P139-HD

DIGITAL AUDIO SYSTEM

BELL 204 / 212/ 412 INSTALLATION

MDL GA212 Rev A STC SR02270SE

G13160 P139-HD
3 BOARD ROUTER
WEIGHT = 5.3 LBS MAX
POWER = 5 AMPS MAX
VOLTAGE = 14 - 32 VDC

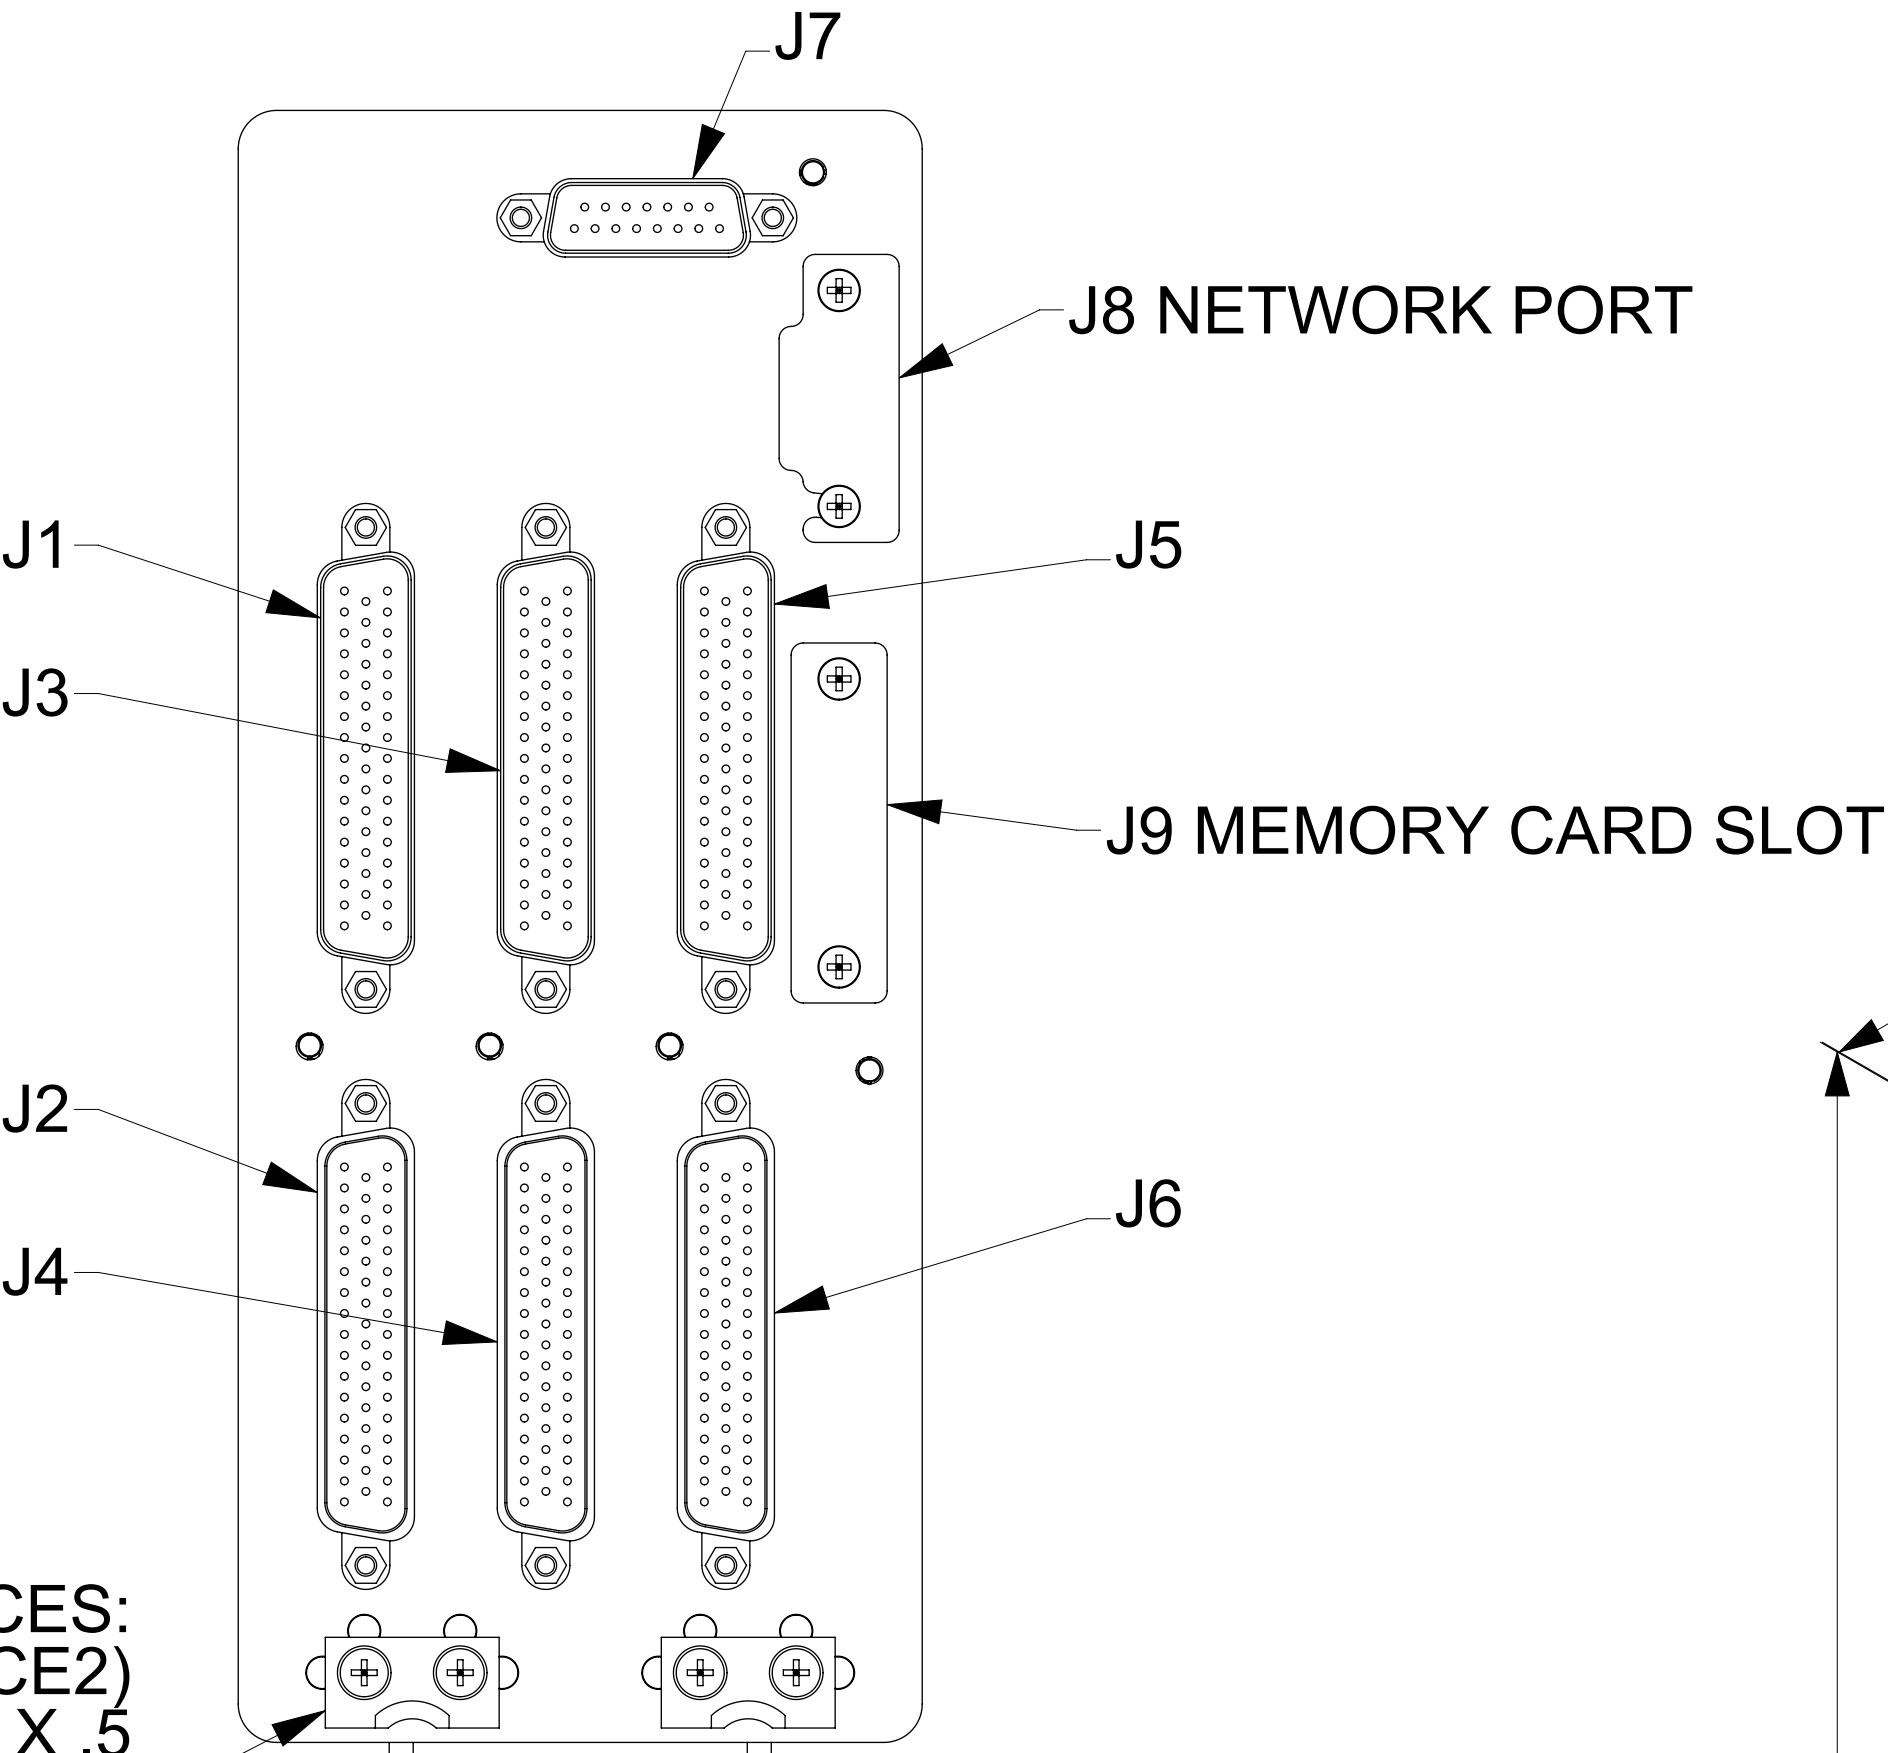
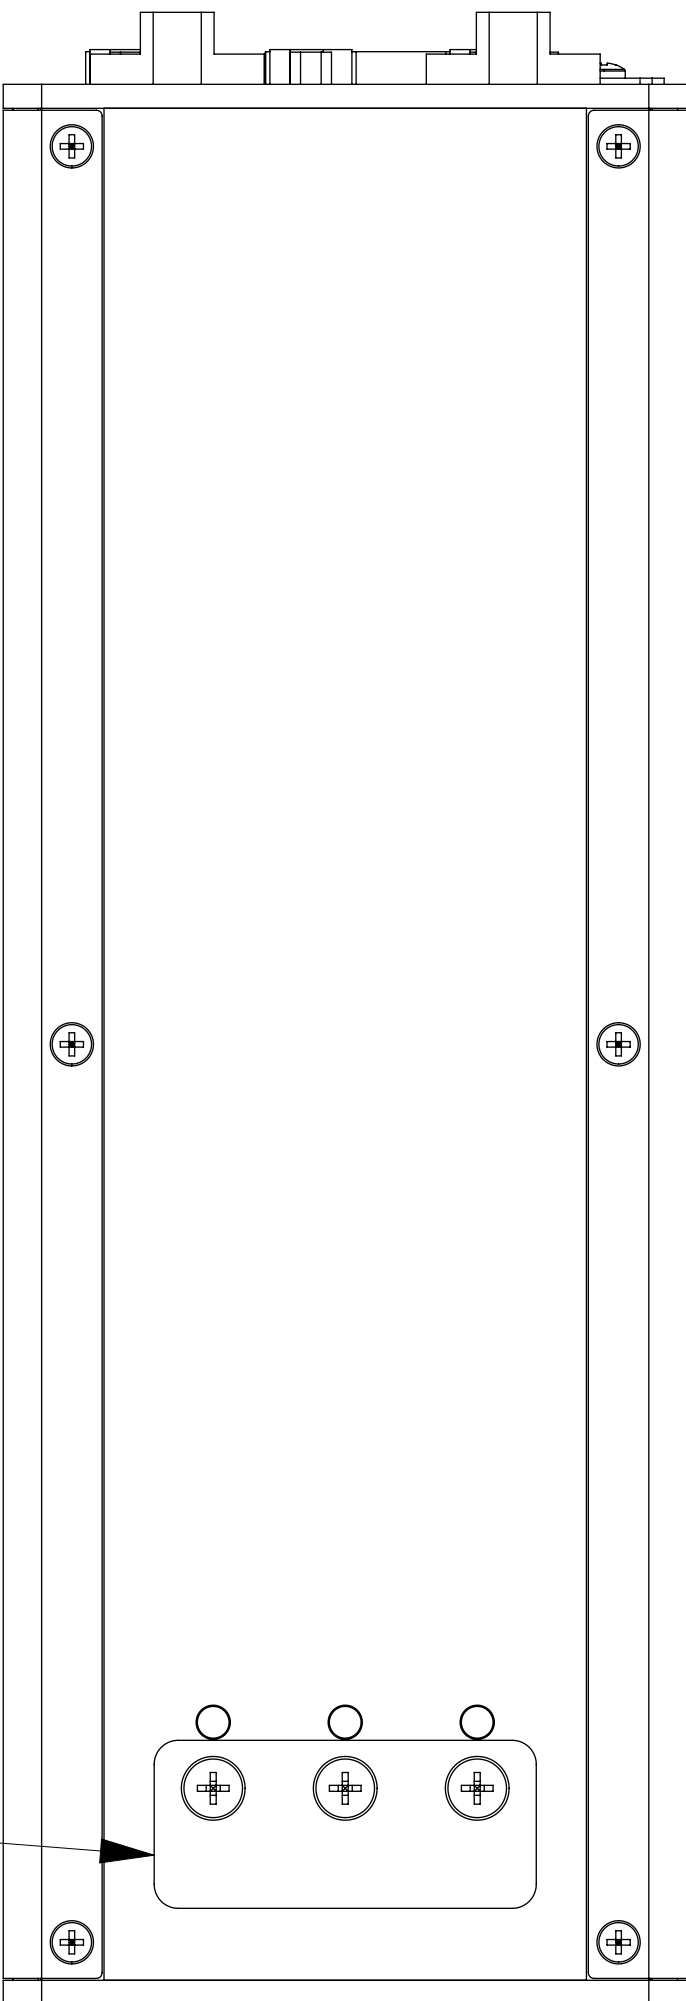
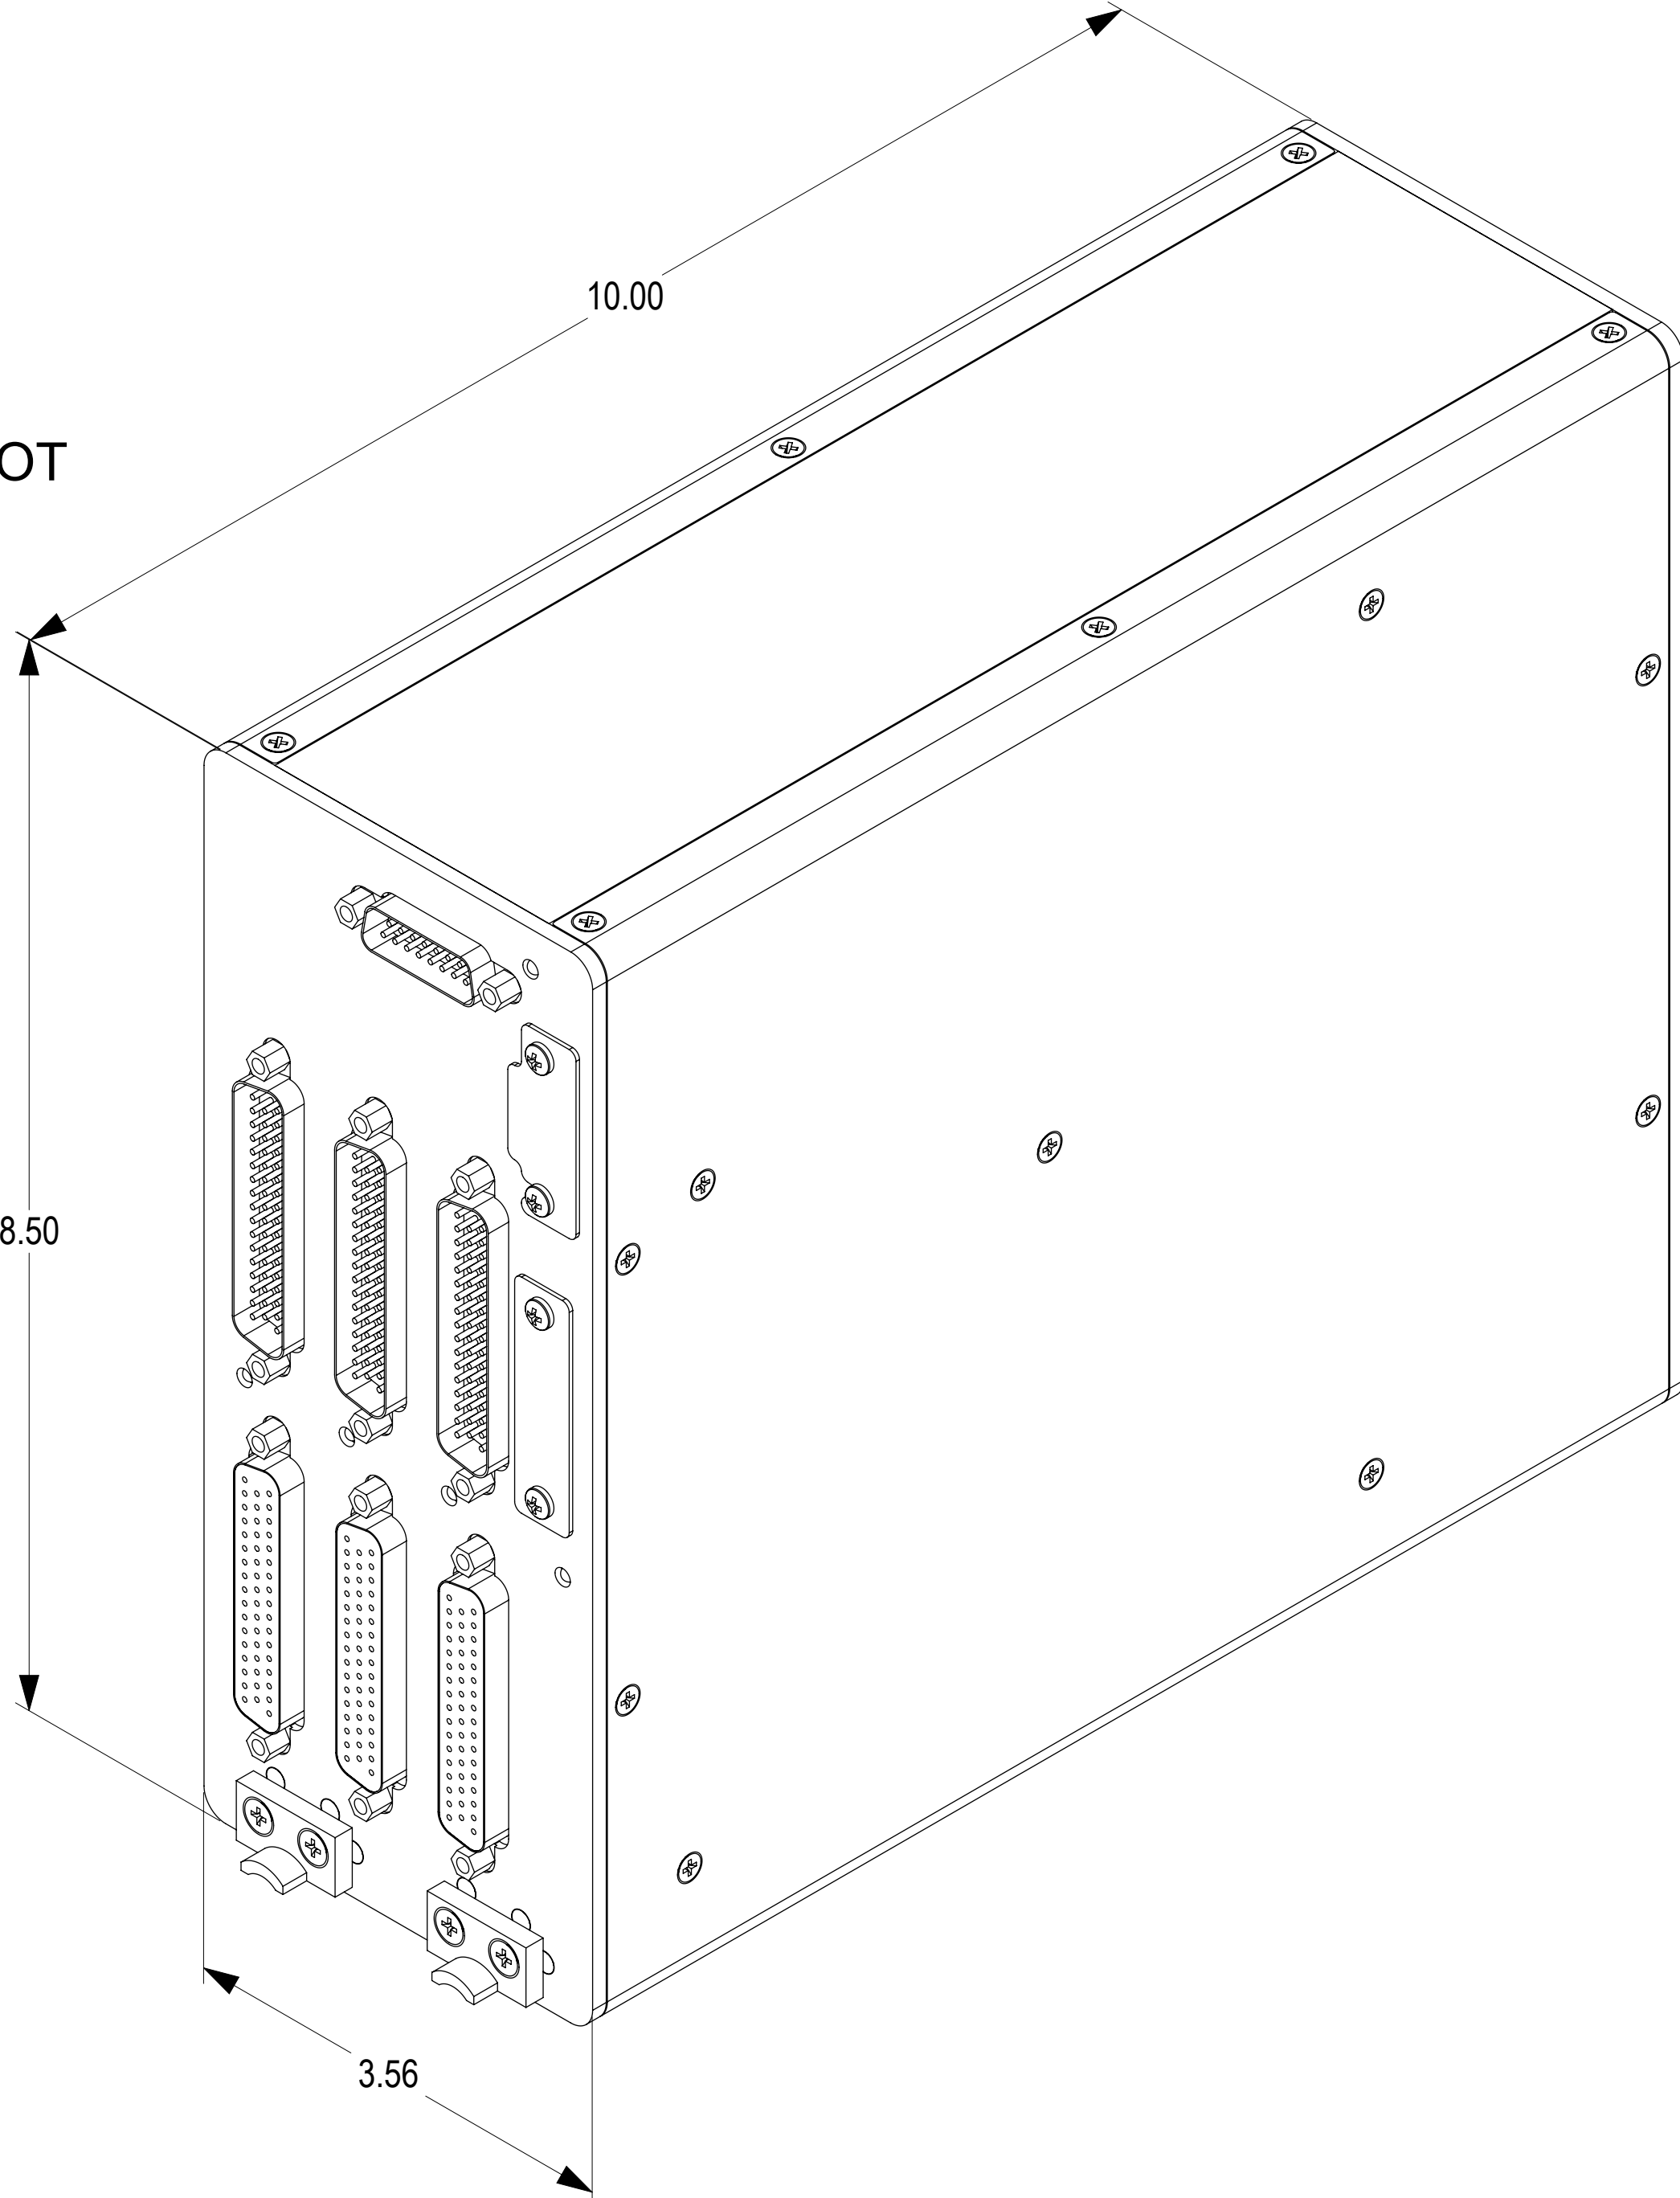
This ECO updates Audio Routers G13000 and G13160 to change the operating voltage from 10 – 30 VDC to 14 – 32 VDC.

REVISIONS		
REV	DESCRIPTION	APPROVED/DATE
A	VOLTAGE RANGE WAS 10 - 30 VDC	08/13/14 CLB
